### **Camden Gas Stage 3 Project Application Response to Submissions Report**

## **Submission on the Camden Gas Stage 3 Project Application Response to Submissions Report**

## **Peer Review of Camden Gas Project Groundwater Investigations**

WRL Technical Report 2012/26  
December 2012

**Figure 1: Monitoring Bore Locations (Source: AGL, 2012)**

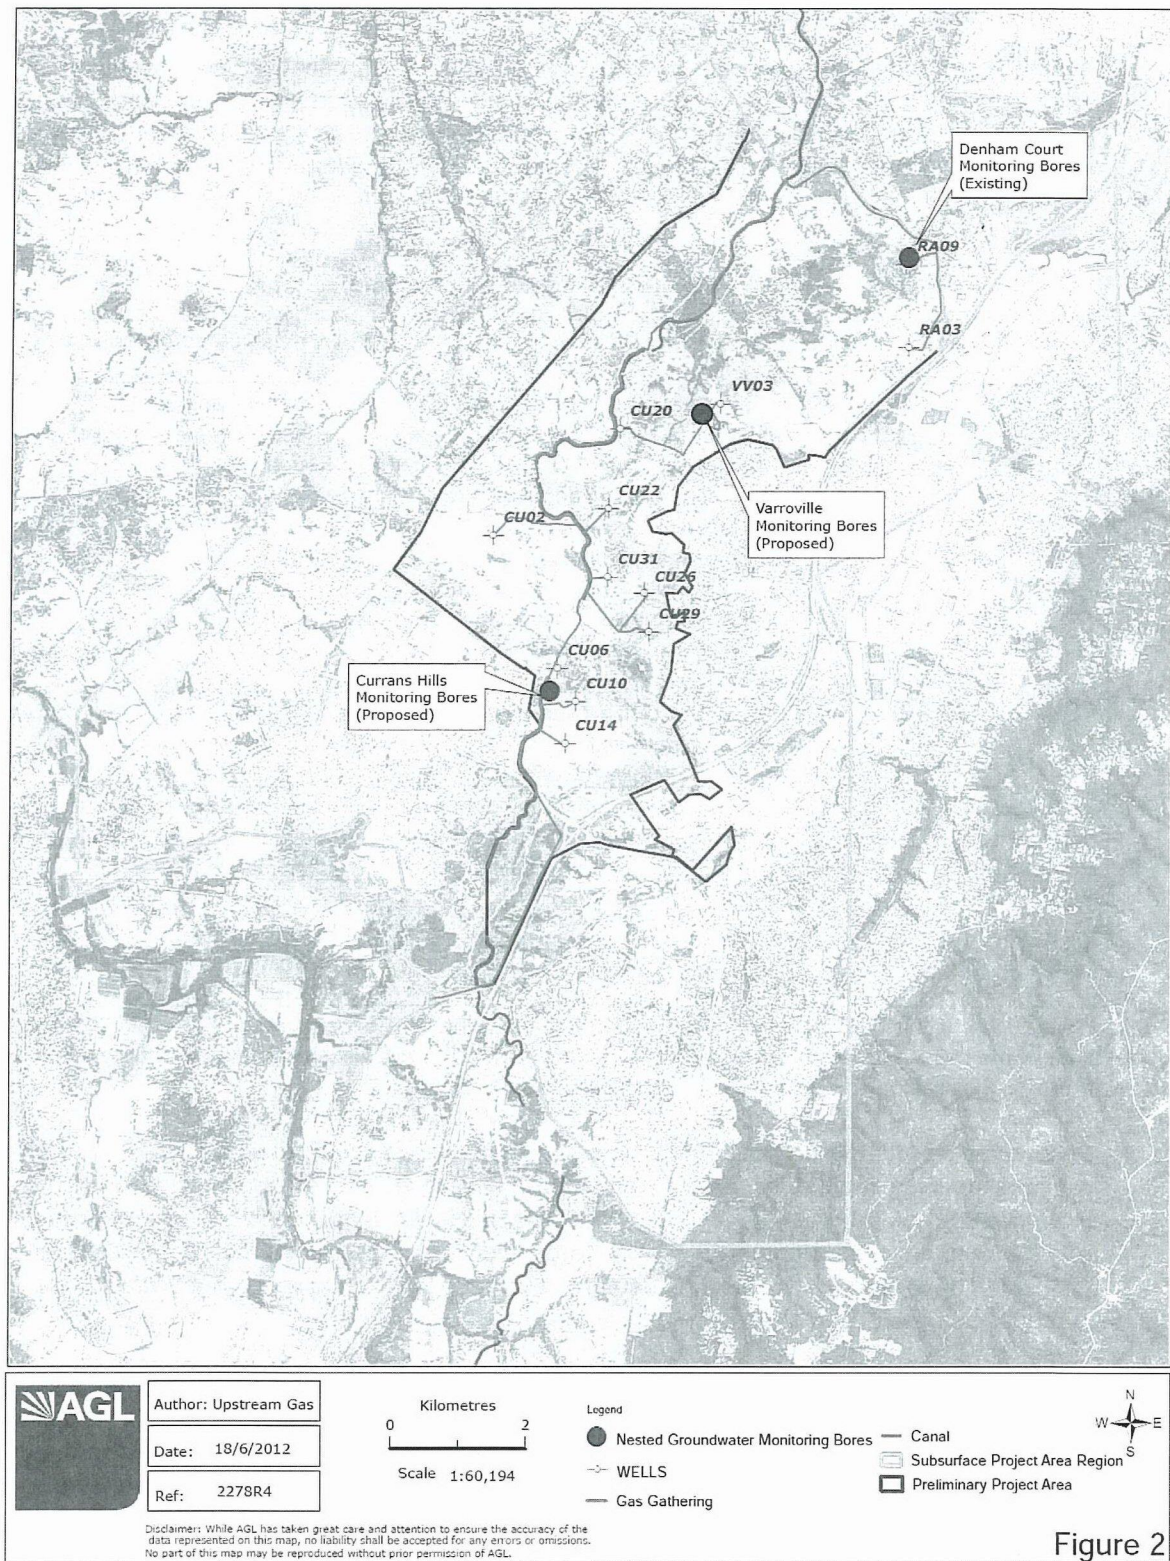
As stated within the AGL Groundwater Management Plan, the aim of the monitoring bores is only to assess impacts within the shallow beneficial aquifers. As such, it is not designed to provide data for a comprehensive analysis of groundwater flows and aquifer behaviour. At each location, it will be possible to obtain relative heads and likely vertical gradients within the shallow aquifers, however this will not provide any information regarding lateral flow. In areas dominated by fracture flow, it will be very difficult to determine the direction of groundwater flow.

The proposed monitoring well configuration in the northern expansion (AGL, 2012) will not give any information regarding groundwater flows and aquifer behaviour in lower aquifers and aquitards. It cannot provide any indication of whether the strata deemed as aquitards are behaving as aquitards or aquifers or how leaky they may be. To obtain this information, additional nested bores would be required, targeting underlying strata, including the claystones. AGL have given the following reasons for not monitoring the Bald Hill Claystones (AGL, 2012):

These reasons neglect the inherent value of quantifying the groundwater processes and flows occurring in all of the strata. Should water level declines occur in the Hawkesbury Sandstone that are attributable to the dewatering of coal seams at depth, AGL have stated that they will install a monitoring bore into the deeper strata below the Bald Hill Claystone to confirm trends. However, this bore would not allow for baseline monitoring within the Bald Hill Claystone to obtain an understanding of groundwater processes that occurred pre-development.

Monitoring of the coal seams is also important to determine how the coal seams will be recharged in the future. While depressurisation may not cause immediate impacts on overlying strata, over time frames of decades or centuries, depressurisation will eventually drawdown overlying waters through leaky aquitards if the coal seams are not recharged. AGL proposes the use of depleted gas wells for monitoring the different aquifer systems in the current Stage 1/Stage 2 existing Camden CSG area, including the very deep groundwater in the Illawarra Coal Measures and the Narrabeen Group, as well as the Hawkesbury Sandstone aquifer. It may be possible to use this data to infer likely recharge mechanisms within the coal seams of the Northern Expansion area, depending on the configuration of wells used, however the groundwater monitoring network and program needs to be planned to encompass this purpose. AGL have also stated that they will monitor water quality at some production wells in the Northern Expansion area similar to the current program for the CGP. However, they have not nominated the number of sites nor which locations they will target.

The conceptual hydrogeological model described in AGL (2010) assumes that depressurisation of the coal seams is unlikely to induce vertical flow of groundwater from the shallow beneficial aquifers due to the presence of low permeability claystone layers. However, it is acknowledged that "the possibility cannot be ruled out that major fault zones could provide a hydraulic pathway through claystone horizons and that some shallow groundwater impacts may be observed close to those structures". As the proposed monitoring bore locations have not been overlain on the map showing the locations of faults, it is difficult to determine the exact intent of locations. The descriptions of the locations, however, suggest that it is only intended that one of the monitoring bores target minor faulting, and that this is intended to be a control site. Given the potential for faults to significantly influence groundwater flows, it is suggested that several nests of

monitoring bores should be located close to faults in the central area of the northern expansion, in as close proximity to intended wells as possible. It would be preferential to install these monitoring bores as soon as possible to allow collection of adequate baseline datasets. This would also help to characterise the spatial variability of groundwater quality across the site, as identified in AGL (2010).
